Car #2 *dlls* 8/27/2024

CLIENT: GILBANE BUILDING COMPANY
SYSTEM: VRC ELEVATOR
ADDRESS: 1095 SOUTHERN BLVD, BRONX, NY 10459

TITLE: CIVIL WORKS
SCALE: N/A DATE: 04/23/24 DRAWN: CHECKED:
DRAWING NO: VRC-UHP-01 SHEET: 1 OF 4

TITLE: EQUIPMENT DESCRIPTION			
SCALE: N/A	DATE: 04/23/24	DRAWN:	CHECKED:
DRAWING NO: VRC-UHP-02	SHEET:	2 OF 4

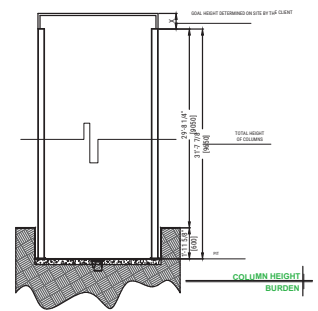
Include soft control cable from 1st box to PLC box.

Elevator Ride Box on this side due to pipes in the way
